VTA's BART SILICON VALLEY— PHASE II EXTENSION PROJECT

NOISE AND VIBRATION TECHNICAL REPORT

November 2017

E.1 Introduction

Figure 1-1
Regional Location (Revised)
 VTA's BART Silicon Valley-Phase II Extension Project

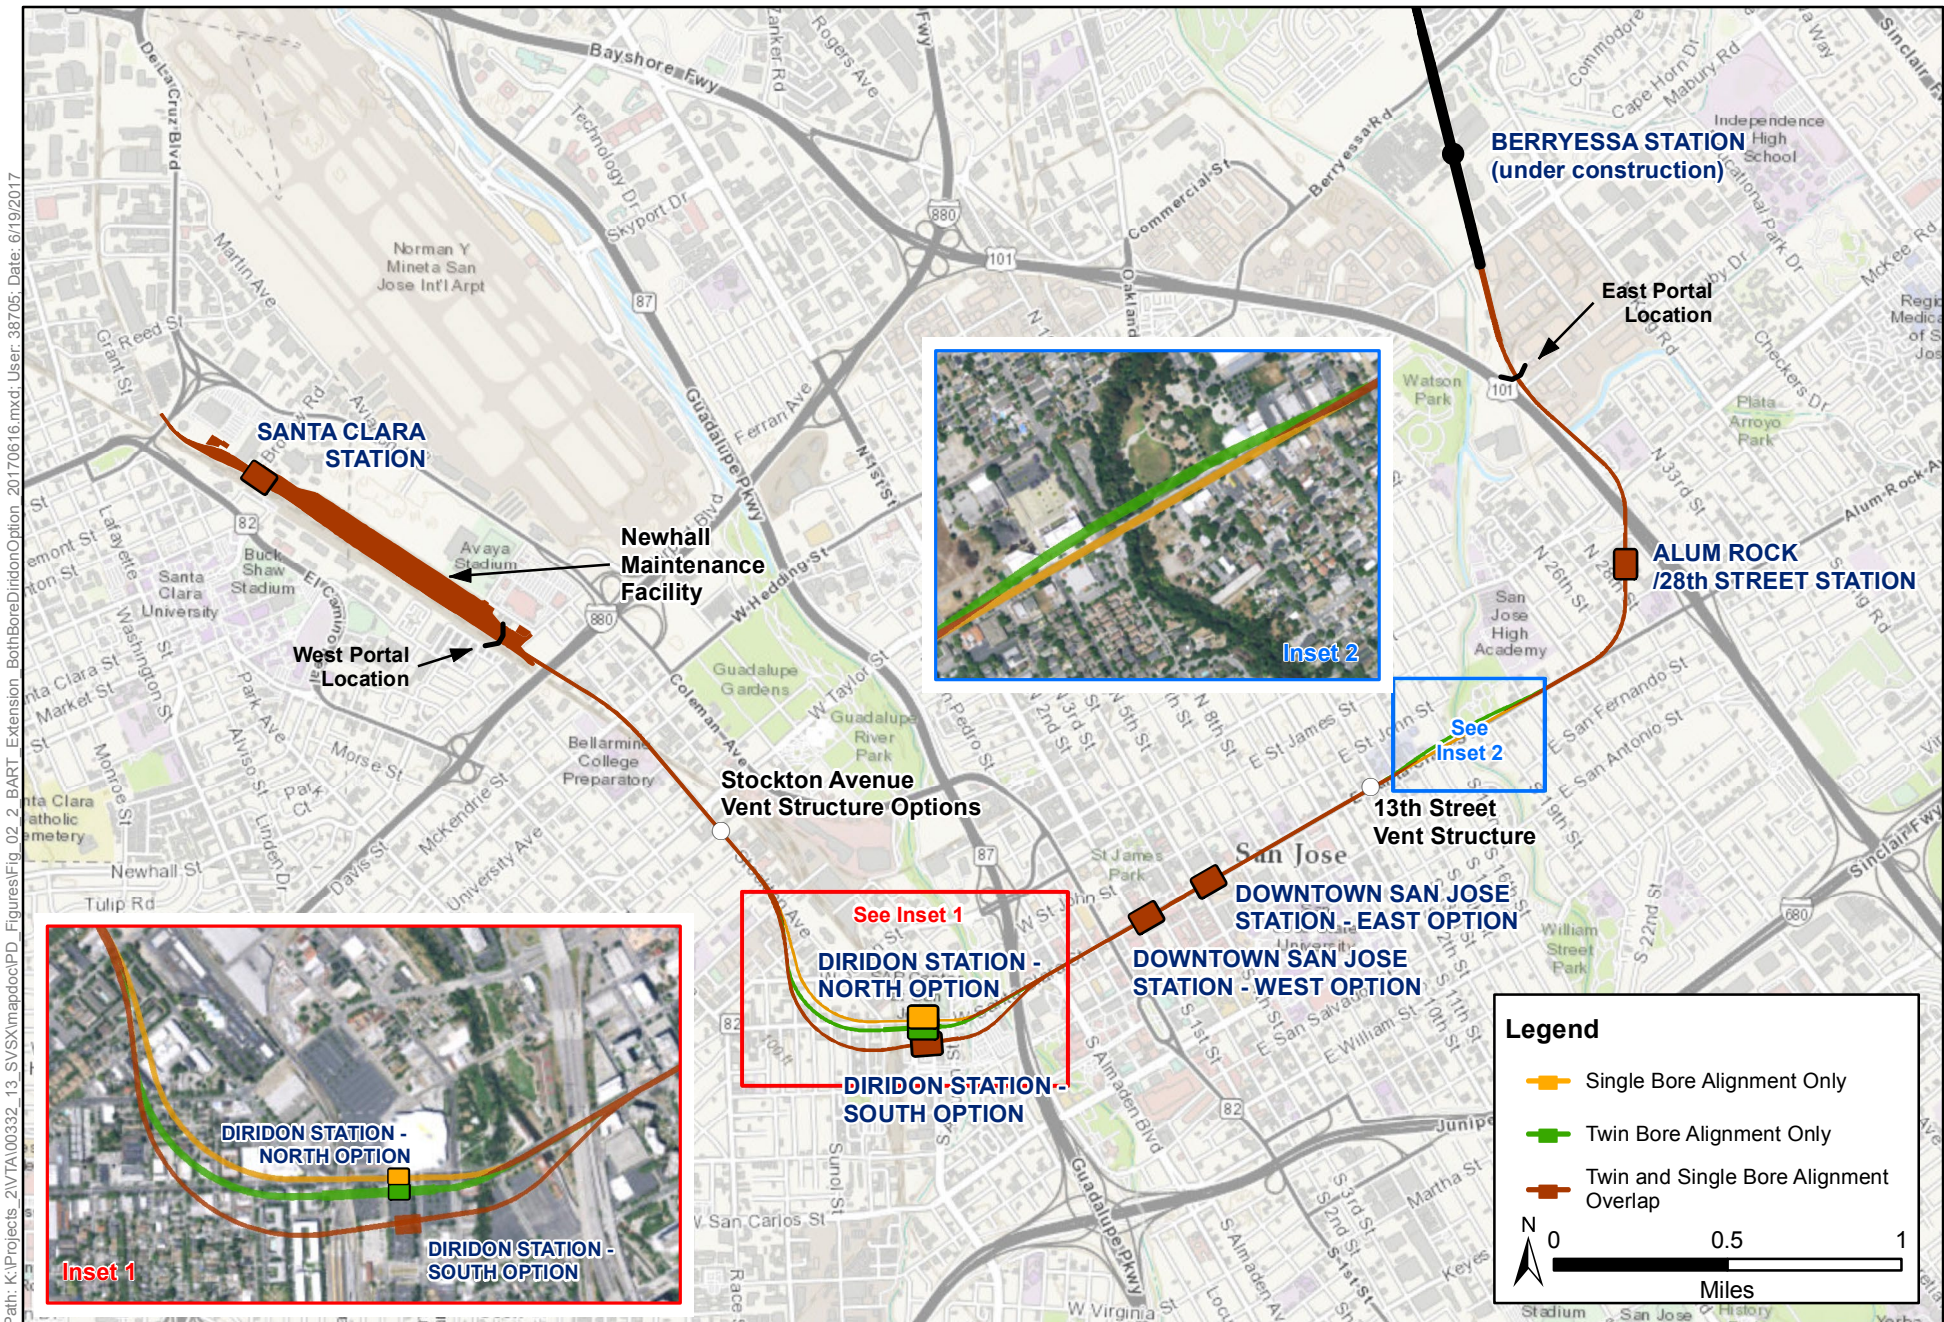
The revised Chapter 1, *Project Description*, is provided at the end of this Errata.
